Access Compliance Report

Public Rights-of-Way

(Curb Ramps)

Intersection ID: 14258	Main Street: BERKELEY_AV	Cross Street: LAFAYETTE_AV	Location: NW
ADA ID: 4F7F2874ADDB	Ramp Type: Directional1	Initial Pass/Fail: Pass	Overall Compliance: No
		Severity Score: 7.5

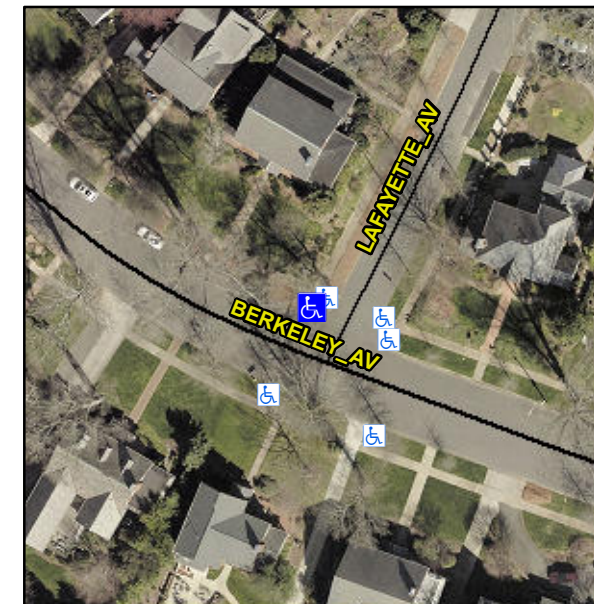
Remove & Replace Detectable Warning System. Remove & Replace Gutter.

R305.1.4, R305.2, R302.7, R304.5.4
